RE: U.S. Patent: 7,109,659  
Issued: September 19, 2006  
Application Serial No.: 10/991,415  
Filing Date: November 19, 2004  
Applicants: Takeshi KAMOI  
For: HIGH-INTENSITY DISCHARGE LAMP BALLAST  
AND METHOD FOR OPERATING HIGH-  
INTENSITY DISCHARGE LAMP  
Group Art Unit: 2821  
Examiner: VO, TUYET THI

**REQUEST FOR CERTIFICATE OF CORRECTION**

UNITED STATES PATENT AND TRADEMARK OFFICE  
**CERTIFICATE OF CORRECTION**

**FIG. 4**

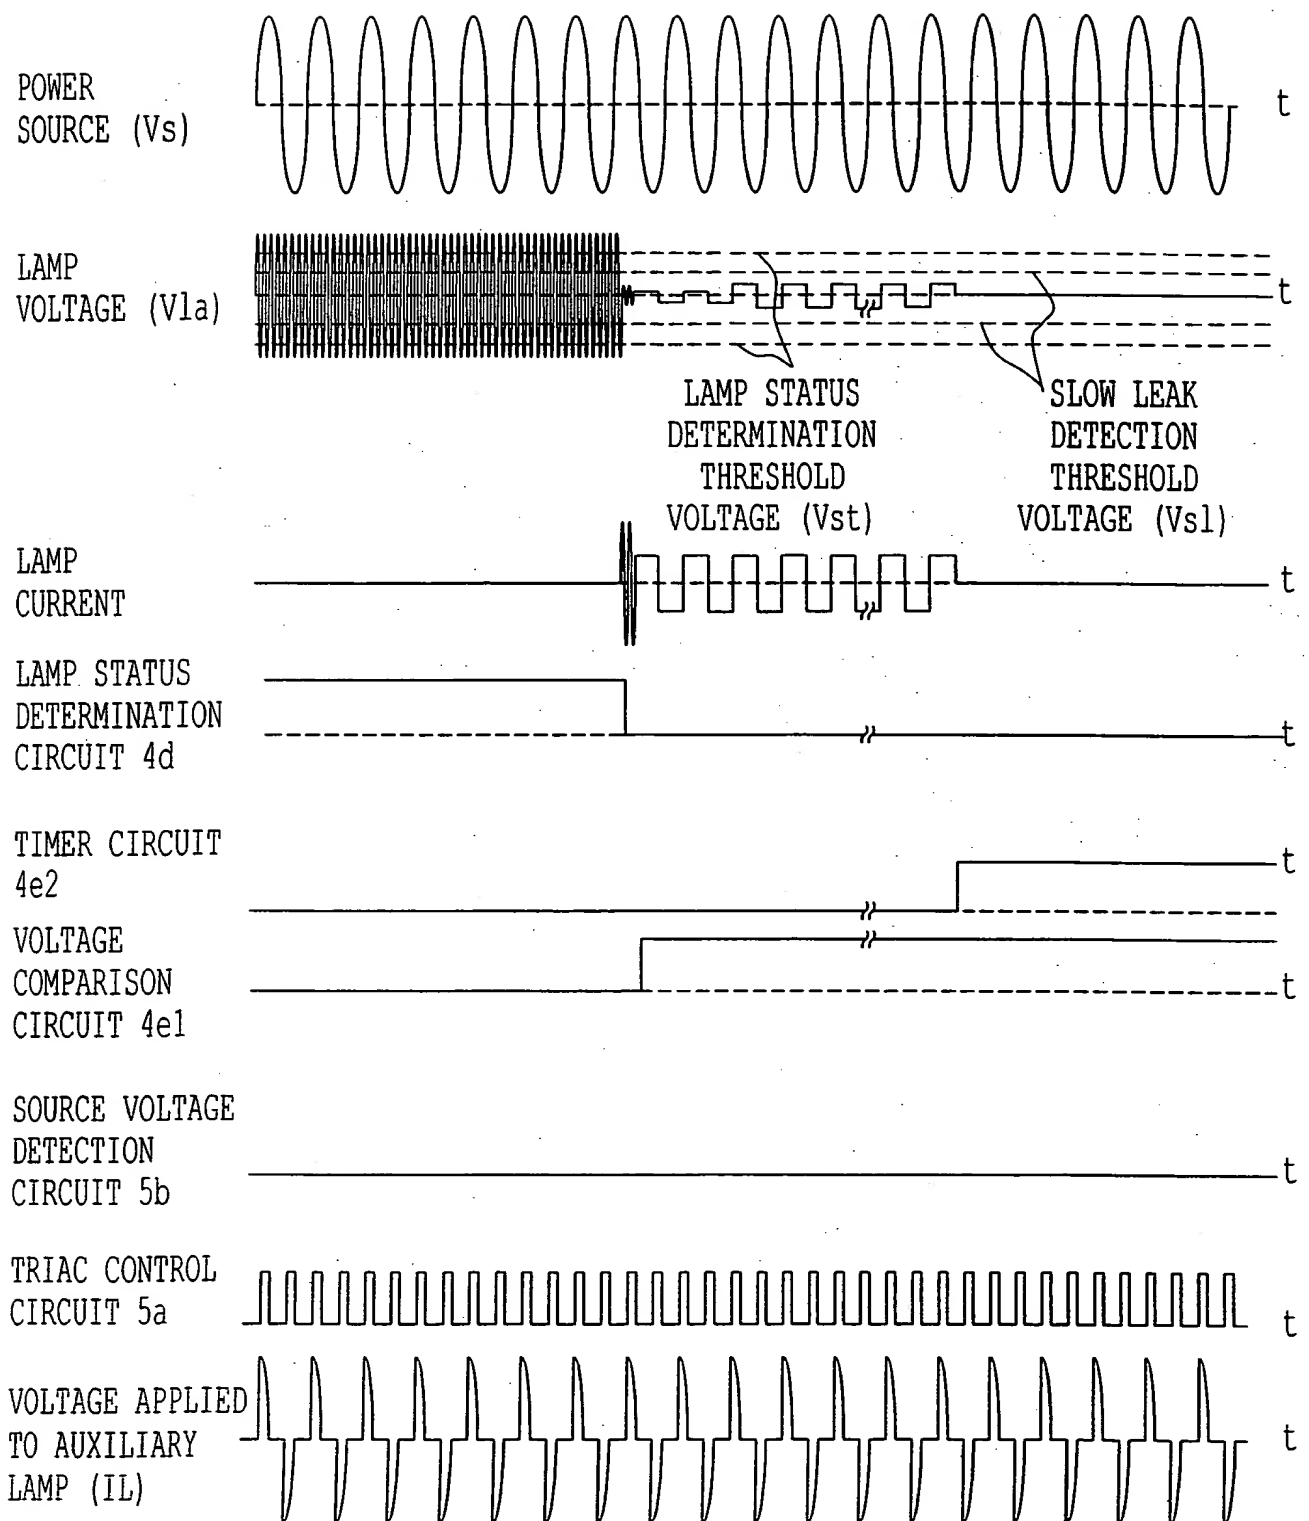
However, the profile of the lamp voltage (Vla) in Figure 4 filed on November 19, 2004, is not consistent with the above descriptions in the ‘659 patent. Specifically, instead of reaching substantially zero as discussed in the specification, the lamp voltage (Vla) continues to increase in Figure 4. Therefore, for the purpose of clarification, Applicant respectfully requests that Figure 4 which appears in the ‘659 patent be replaced with corrected Figure 4 attached herewith.

Please replace Fig. 4 with the corrected Fig. 4 attached herewith.

FIG. 4

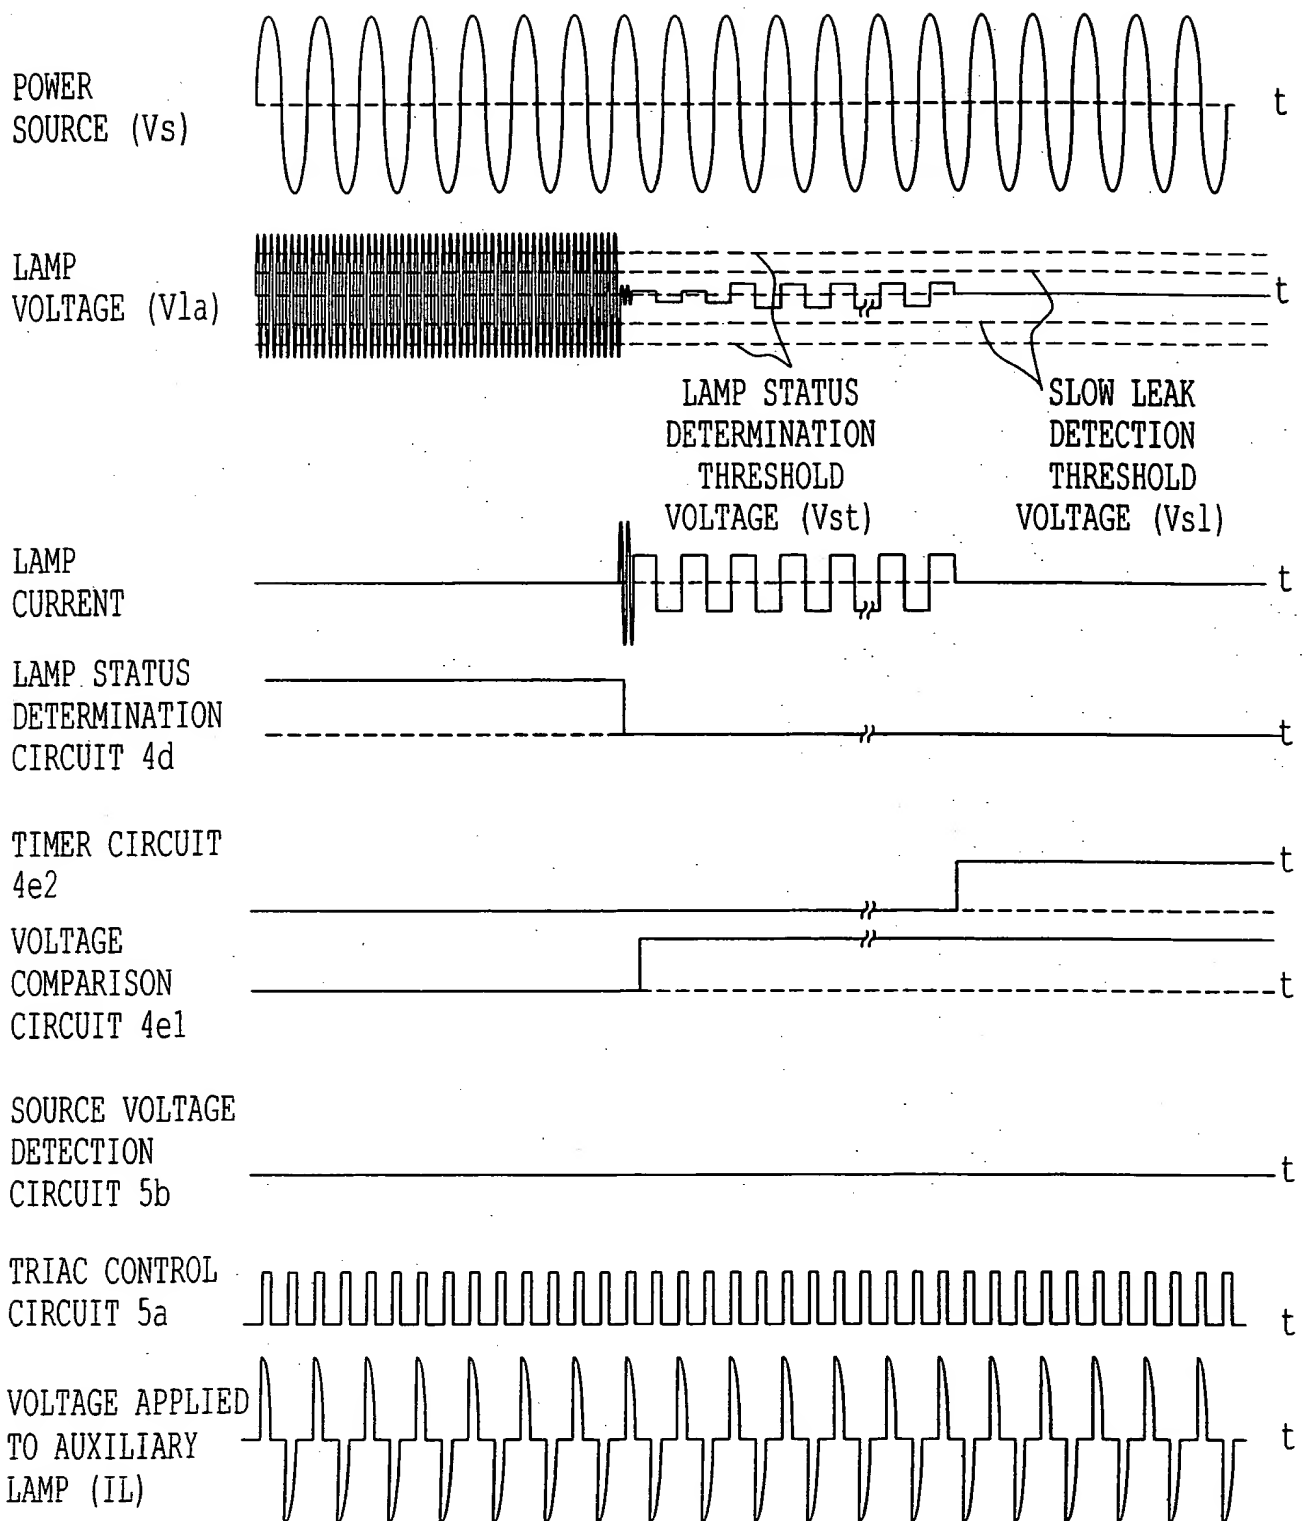
Please replace Fig. 4 with the corrected Fig. 4 attached herewith.
